| 4 | Dec. 07, 2015 |

**PHASE 3B
ROUND HILL
ELEMENTARY SCHOOL**
Roanoke, Virginia
2020 Oakland Blvd. NW

**DRAINAGE
DETAILS &
DESCRIPTIONS**

SHEET
SP-12

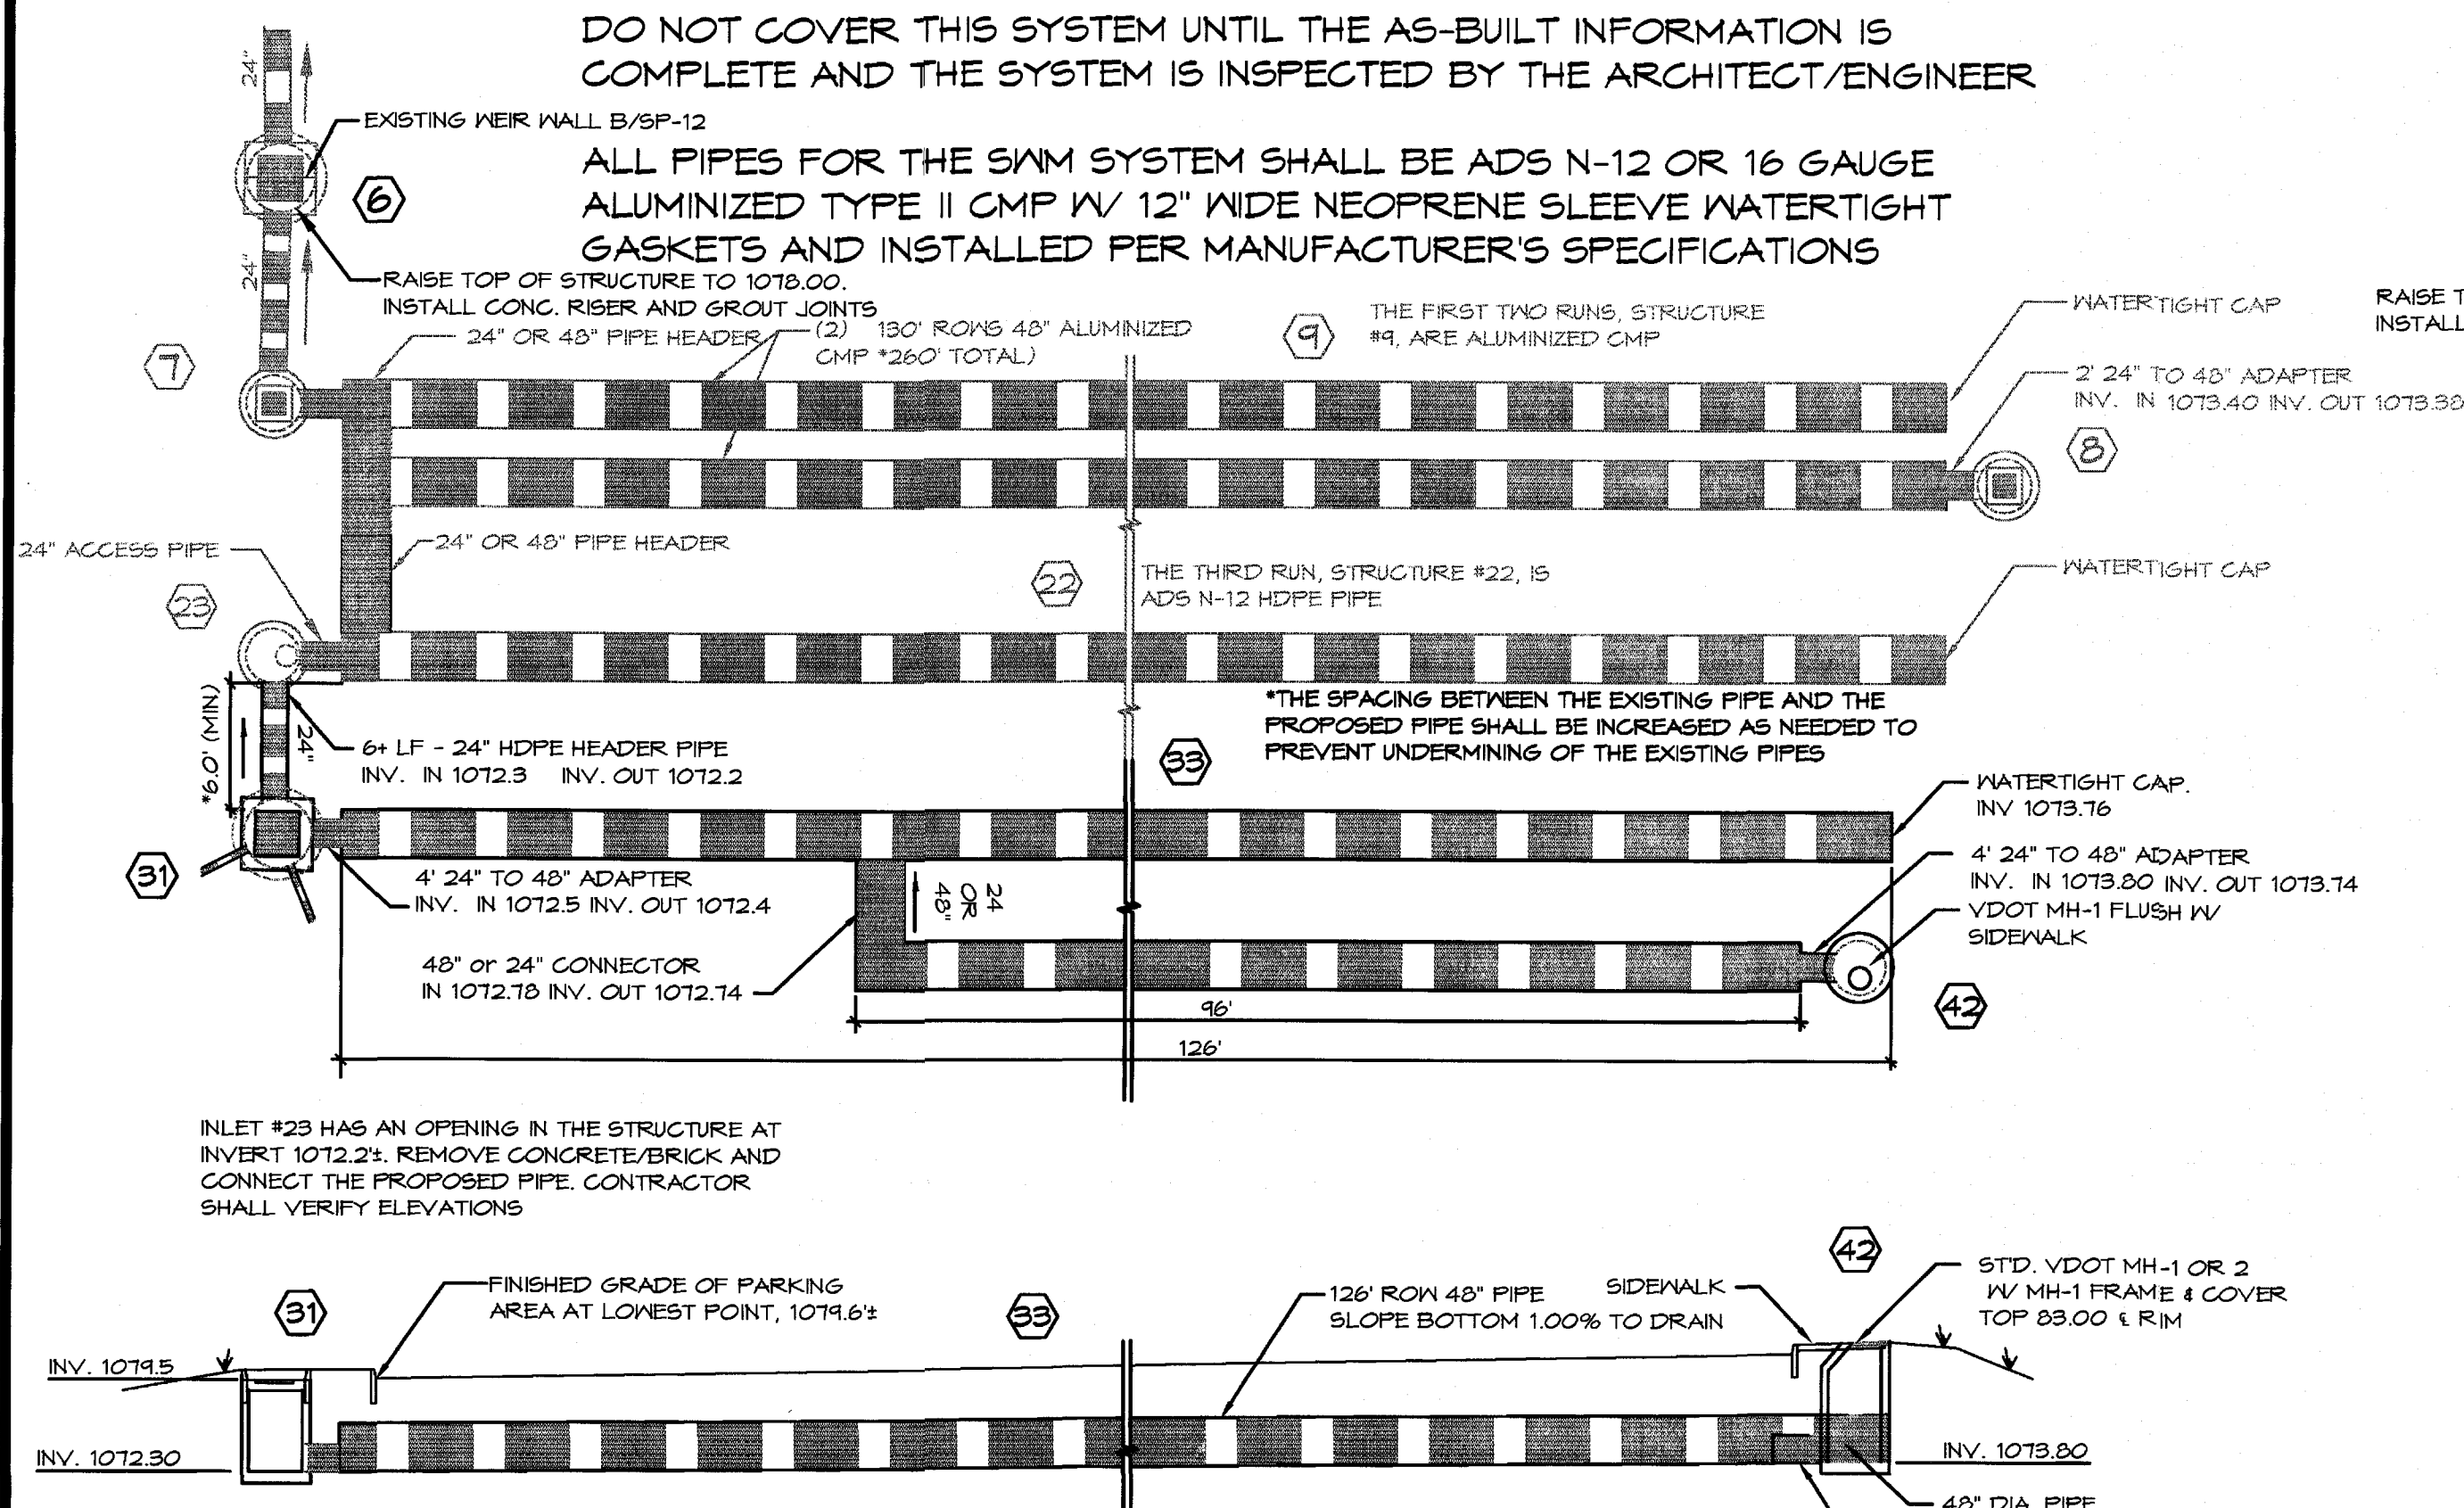
ALL OF THE DETAILS ON THIS SHEET HAVE BEEN MODIFIED WITH ADDITIONAL INFORMATION TO AID IN CONSTRUCTION AND LAYOUT. CONTRACTOR SHALL REVIEW THIS SHEET IN ITS ENTIRETY.

DRAINAGE DESCRIPTIONS

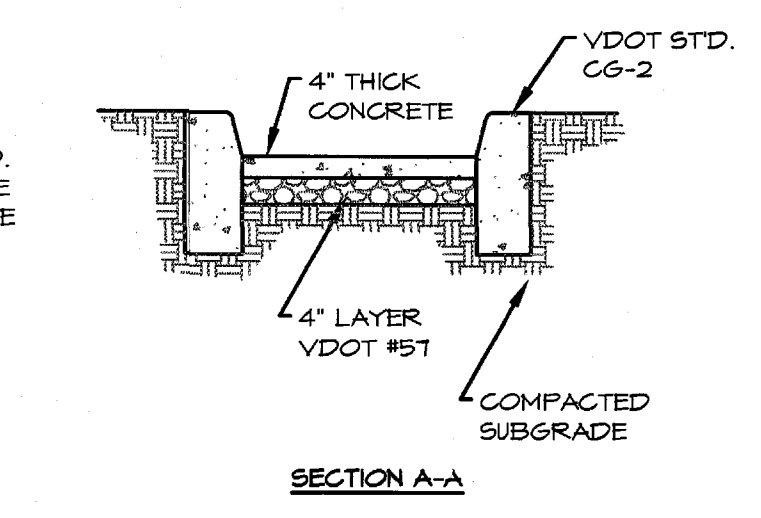
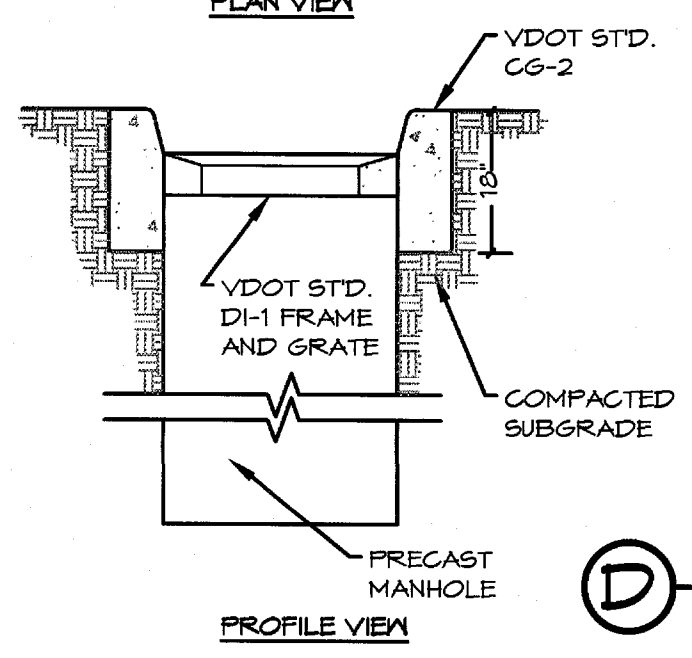
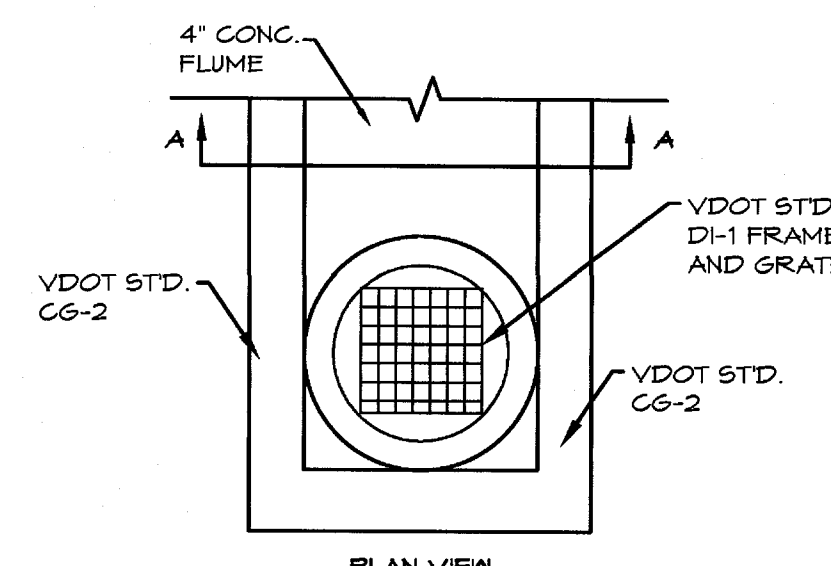
THESE TWO DRAINAGE DESCRIPTIONS WERE ADDED ALONG WITH TREE SPECIES FOR THE FILTERRA UNITS. A GOOD NUMBER OF THE DRAINAGE ITEMS WERE ADJUSTED SLIGHTLY TO ADDRESS REVIEW COMMENTS. CONTRACTOR SHALL REVIEW ALL DRAINAGE DESCRIPTIONS.
